**Re: In the Matter of the Application of AEP Ohio Transmission Company, Inc. for Amendment to the Certificate of Environmental Compatibility and Public Need for the Barnesville-Summerfield 138 kV Transmission Line Rebuild Project
Case No. 19-1068-EL-BTA**

AMENDMENT CHANGE SUMMARY

Exhibit 1: Summary of the Changes to the Preferred Route

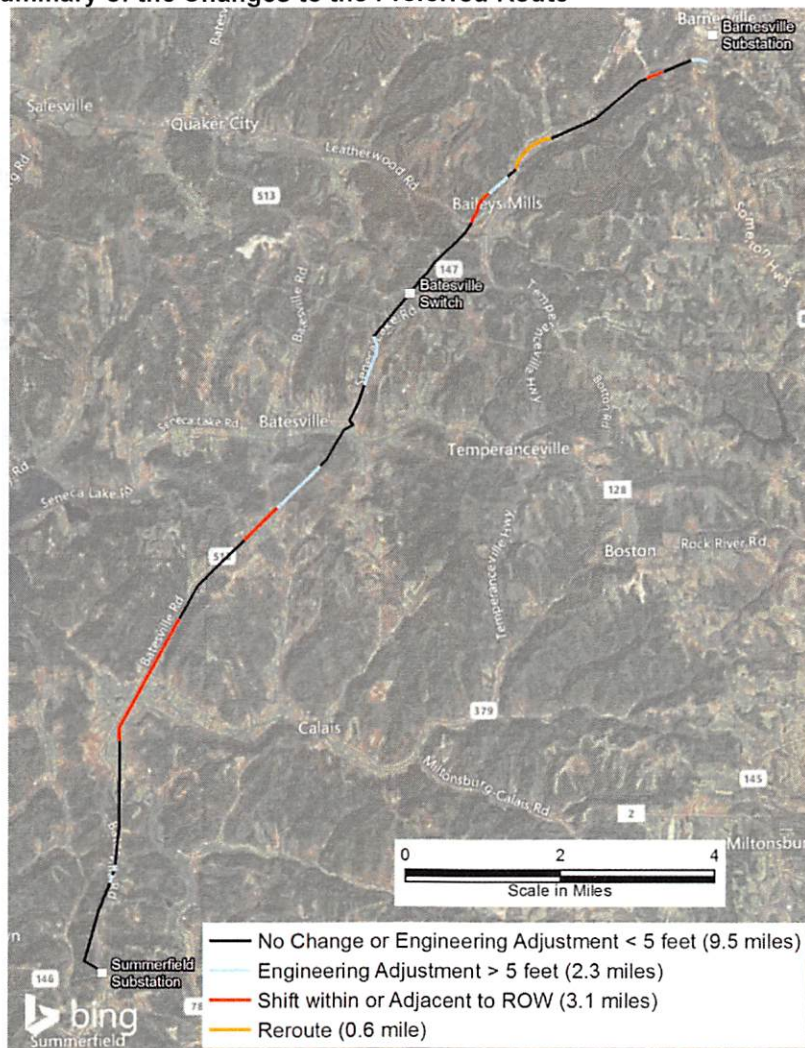
Detailed engineering and property owner negotiations resulted in thirteen areas of change to the OPSB-Approved Route. These changes comprise three categories: (1) seven engineering adjustments; (2) five shifts to rebuild on existing centerline rather than offset, or to the other side of the existing centerline within the existing right-of-way (ROW); and (3) a reroute that deviates from the existing or initially proposed ROW.

Exhibit 2: Engineering Adjustment 1

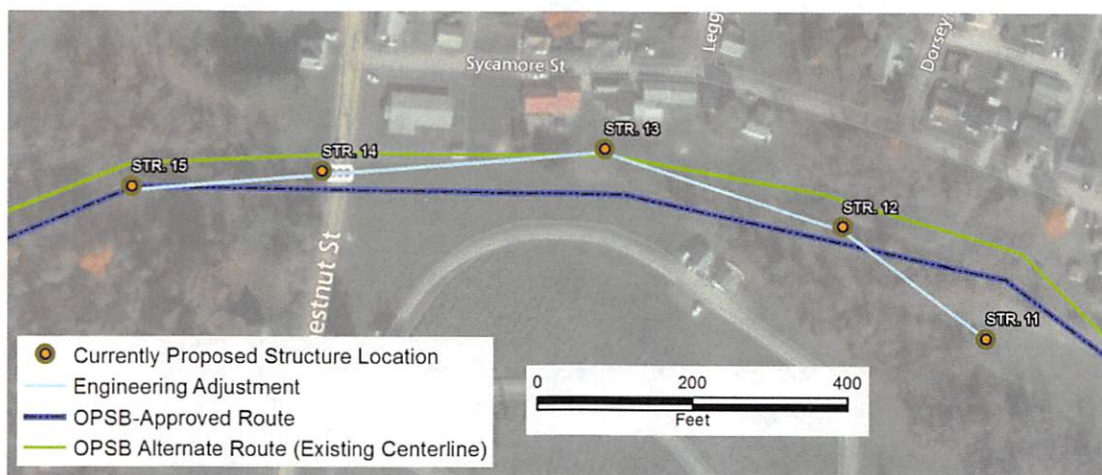
Engineering Adjustment 1 occurs between Structures 11 and 15. The original centerline conflicted with a natural gas pipeline ROW. The newly proposed alignment shifts the OPSB-approved alignment further south at Structure 11 with a maximum adjustment of approximately 75 feet from the OPSB-approved centerline. The remainder of the newly proposed alignment from approximately Structure 12 through Structure 15 shifts the OPSB-approved alignment north. This shift pushes the newly proposed alignment closer to the residences along Sycamore Street; however, no buildings are mapped within the 100-foot ROW. No additional environmental (including tree clearing) or landowner impacts are expected due to Engineering Adjustment 1.

Exhibit 3: Engineering Adjustment 2

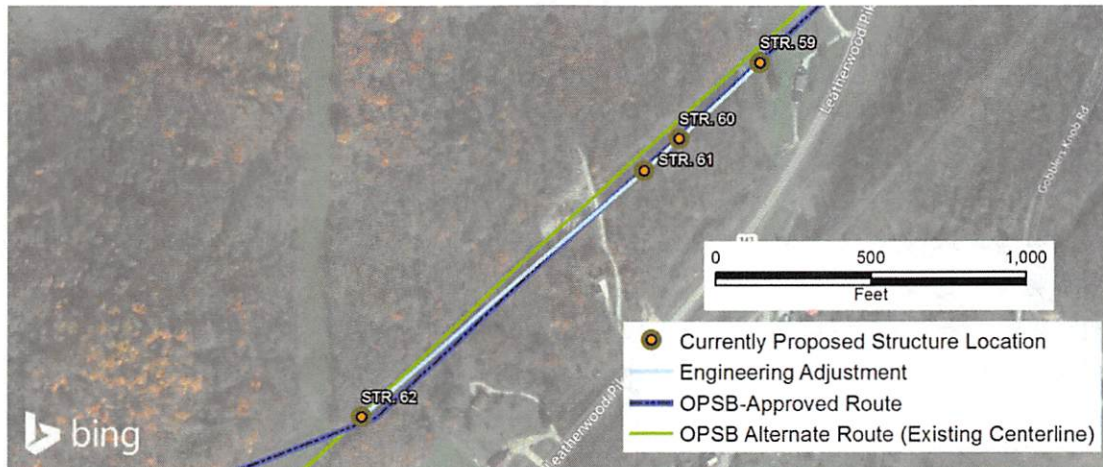
Engineering Adjustment 2 occurs between Structures 59 and 62. Pole locations were adjusted slightly based on detailed survey information and to correspond with more significant changes to the north and south. The maximum adjustment from the OPSB-approved centerline is 19 feet at Structure 62. The amended route results in approximately 4.1 acres of tree clearing within the proposed 100-foot ROW. This is slightly more than the 4.0 acres of tree clearing required for the OPSB-approved route. No additional environmental or landowner impacts are expected due to Engineering Adjustment 2.

Exhibit 4: Engineering Adjustment 3

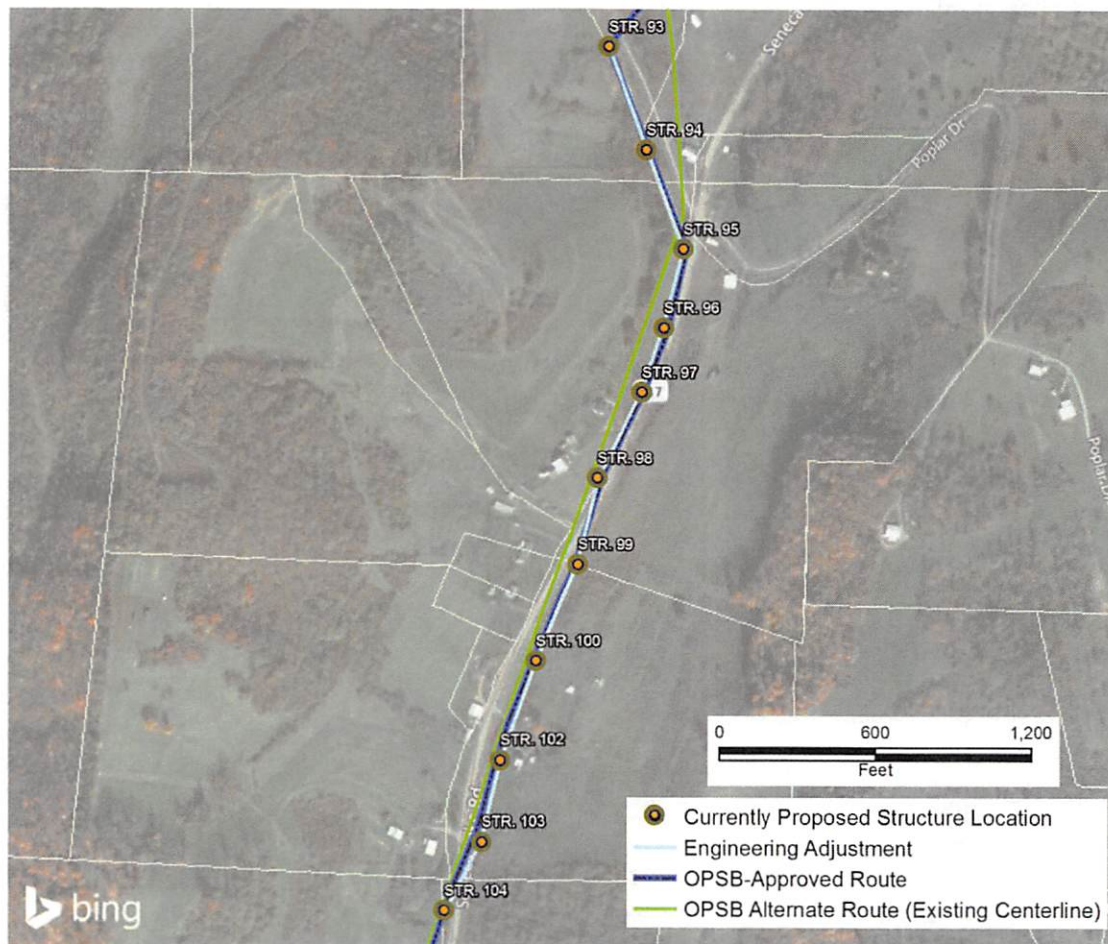
Engineering Adjustment 3 occurs between Structures 93 and 104. The centerline was adjusted to improve the clearance to the nearby distribution line and due to the underground utilities within the area. The maximum adjustment from the OPSB-approved centerline is 38 feet at Structure 103. This adjustment has been constructed. No additional environmental (including tree clearing) or landowner impacts resulted due to Engineering Adjustment 3.

Exhibit 5: Engineering Adjustment 4

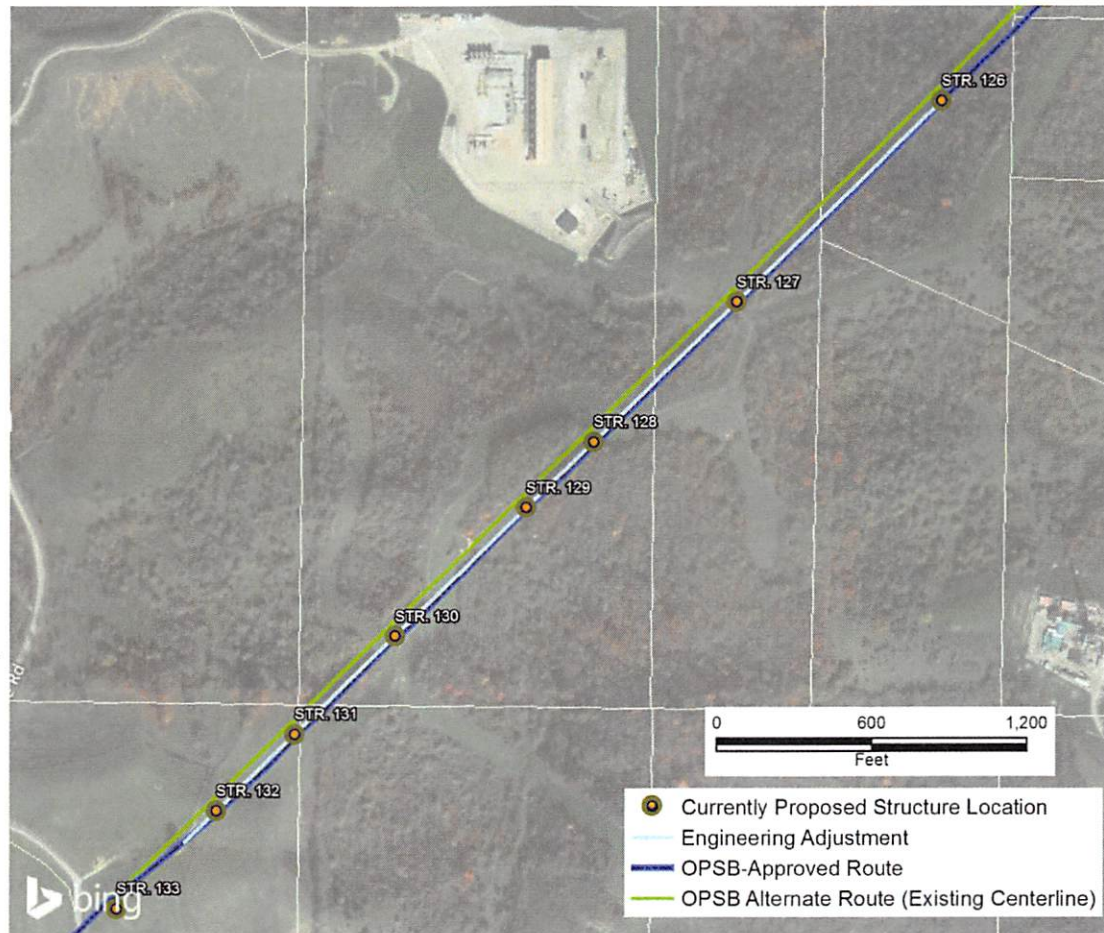
Engineering Adjustment 4 occurs between Structures 126 and 132. These pole locations shifted between one and 11 feet as a result of detailed survey information and minor engineering adjustments. This change reduces tree clearing from approximately 5.5 acres to 4.8 acres. This adjustment has been constructed. No additional environmental (including tree clearing) or landowner impacts resulted due to Engineering Adjustment 4.

Exhibit 6: Engineering Adjustment 5

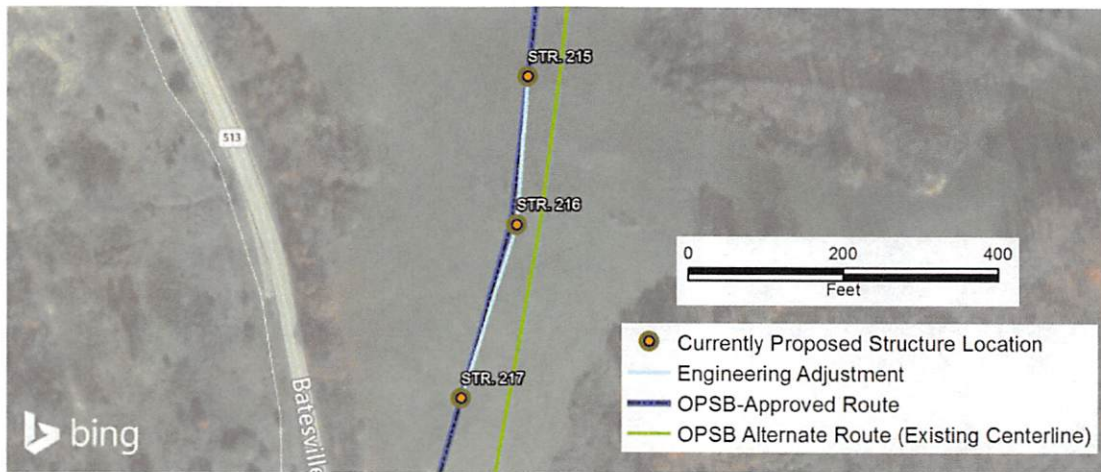
Engineering Adjustment 5 occurs between Structures 215 and 217. The centerline was shifted to avoid an existing well head near structure 216. The well head was discovered within this area after the time of application submittal. Structure 216 was adjusted eight feet from the OPSB-approved centerline. This adjustment has been constructed. No additional environmental (including tree clearing) or landowner impacts resulted due to Engineering Adjustment 5.

Exhibit 7: Engineering Adjustment 6

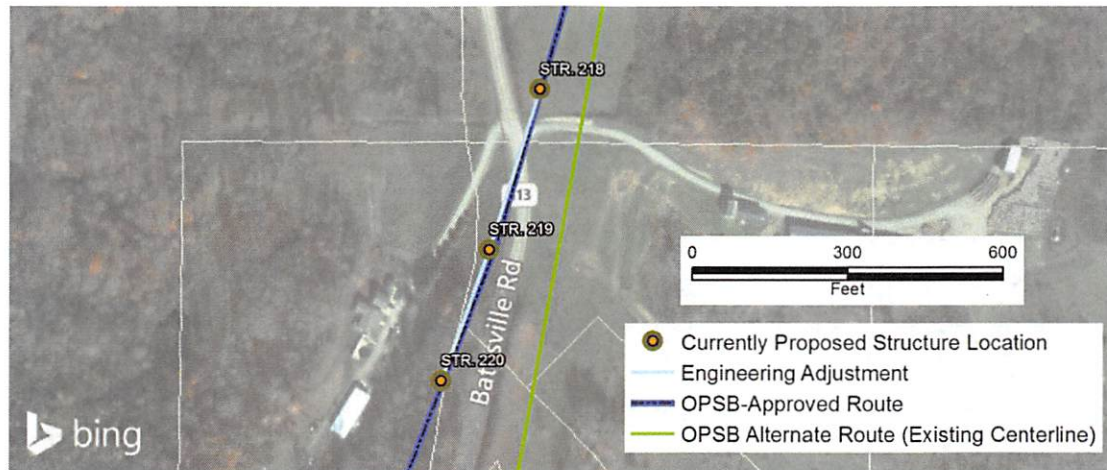
Engineering Adjustment 6 occurs between Structures 218 and 220. The centerline was adjusted to avoid a natural gas line near structure 219. The maximum adjustment from the OPSB-approved centerline is 10 feet at Structure 219. This adjustment has been constructed. No additional environmental (including tree clearing) or landowner impacts resulted due to Engineering Adjustment 6.

Exhibit 8: Engineering Adjustment 7

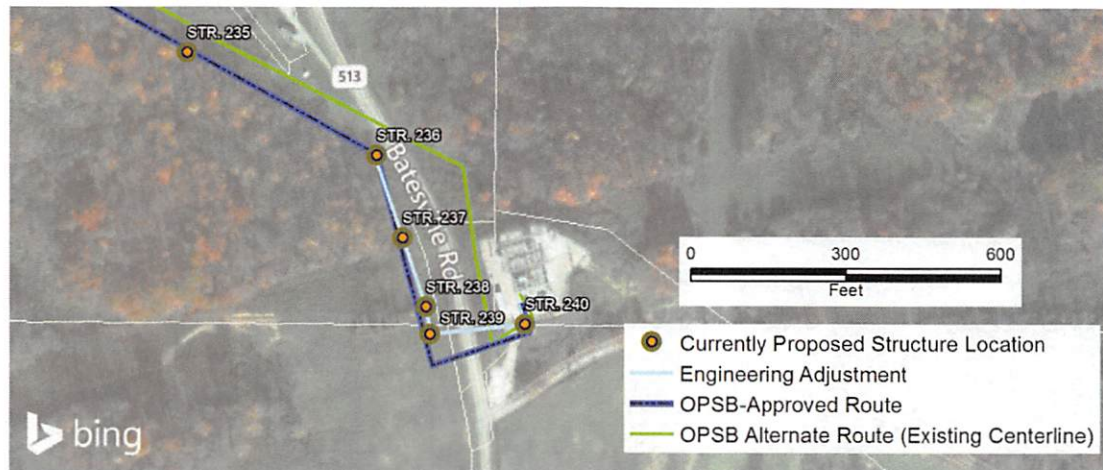
Engineering Adjustment 7 occurs between Structures 236 and 240. The centerline was adjusted to improve clearances to the existing power lines within the area. The maximum adjustment from the OPSB-approved centerline is 17 feet at Structure 238. This adjustment has been constructed. No additional environmental (including tree clearing) or landowner impacts resulted due to Engineering Adjustment 7.

Exhibit 9: Shift 1

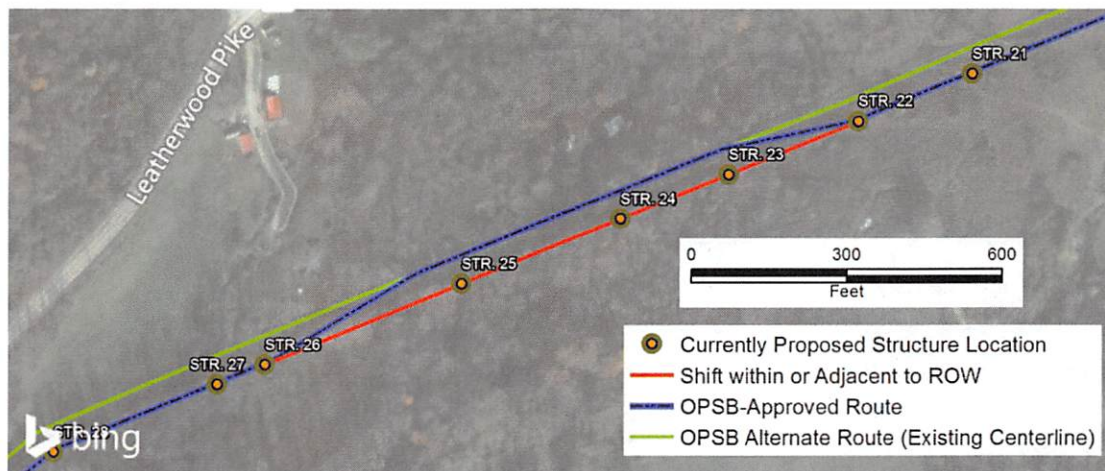
Shift 1 moves the route to an offset position from the existing line consistent with adjacent sections of the centerline between Structures 22 and 26. At the time of submission of the original application, the property owner within this area had suggested that AEP Ohio Transco rebuild on existing centerline. Since then, a new easement has been secured through coordination with the property owner that will allow for construction clear of the existing centerline. By building offset from the existing centerline, AEP Ohio Transco is able to improve safety during construction by constructing clear of the existing line. Shift 1 would potentially result in approximately 0.9 acre of additional tree clearing on the south side of the amended route, which lies outside of the existing centerline ROW. No additional environmental or landowner impacts are expected due to Shift 1.

Exhibit 10: Shift 2

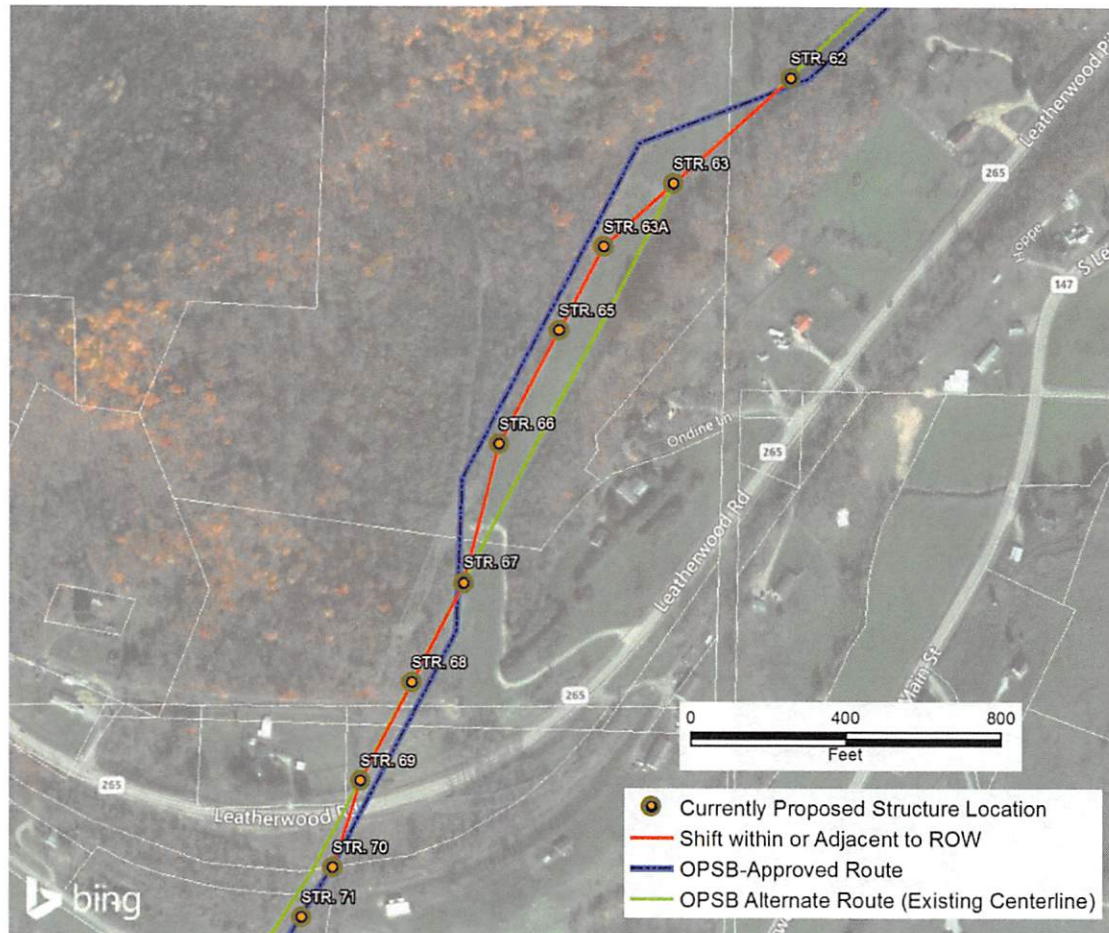
Shift 2 is between Structures 62 and 70. Structures 62-63 and 67-69 are proposed to be shifted onto the existing centerline. Between Structures 63 and 67, the proposed route is in between the OPSB approved centerline and the existing centerline. This shift resulted from the discovery of a natural gas pipeline in the area. The reroute avoids the gas pipeline easement. No additional environmental (including tree clearing) or landowner impacts are expected due to Shift 2.

Exhibit 11: Shift 3

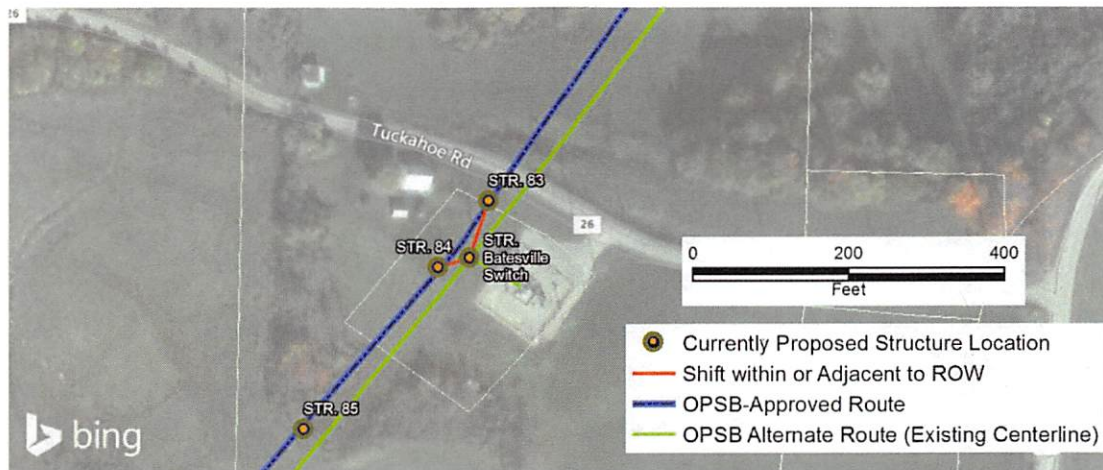
Shift 3 adjusts the alignment between Structures 83 and 84 to attach to the existing Batesville Switch. This shift within the existing ROW did not add any additional parcels or landowners. No new environmental impacts are anticipated. No additional pole will be installed as the centerline shift is to attach to the existing Batesville Switch pole. This adjustment has been constructed. No additional environmental (including tree clearing) or landowner impacts resulted due to Shift 3.

Exhibit 12: Shift 4

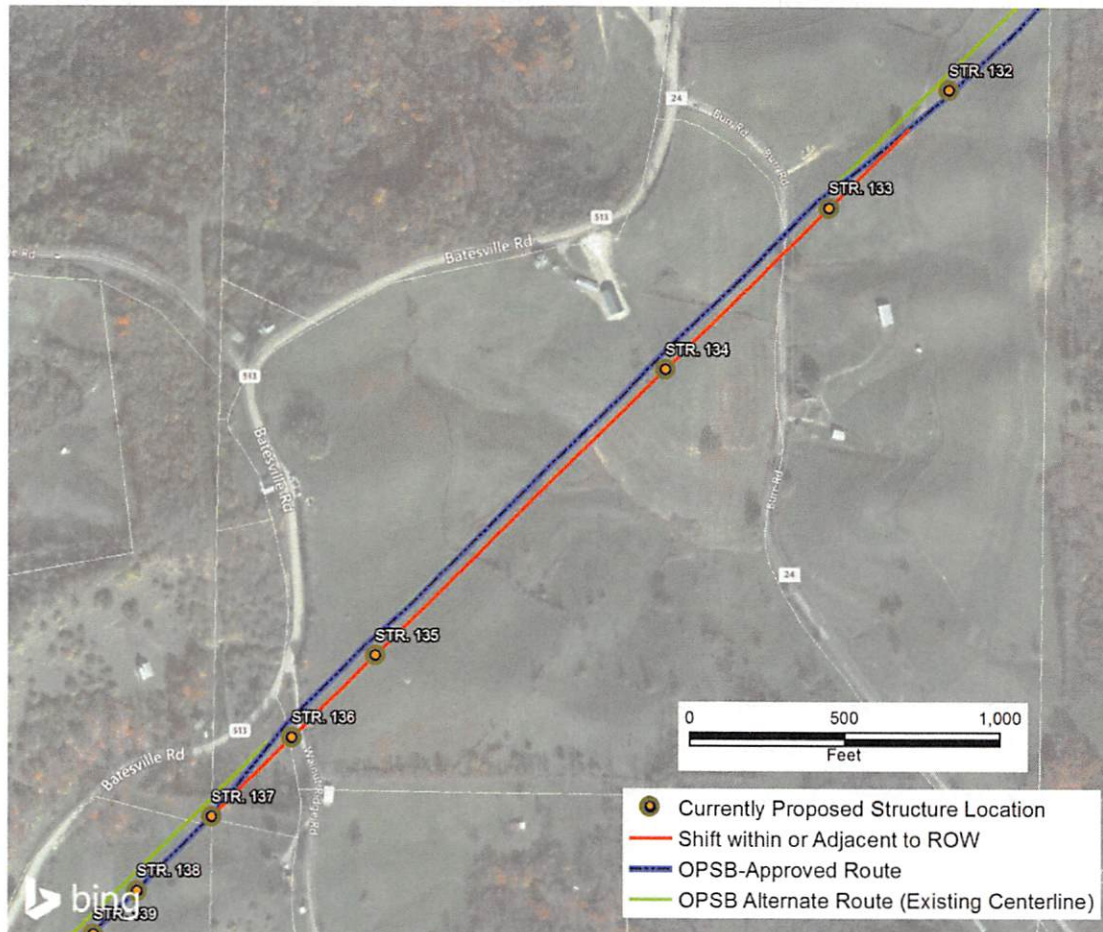
Shift 4 moves the route from the existing centerline to offset between Structures 132 and 137. At the time of submission of the original application, the property owner within this area had suggested that AEP Ohio Transco rebuild on existing centerline. Since then, a new easement has been secured through coordination with the property owner that will allow construction clear of the existing centerline. By building offset from the existing centerline, AEP Ohio Transco is able to improve safety during construction. This adjustment has been constructed. No additional environmental (including tree clearing) or landowner impacts resulted due to Shift 4.
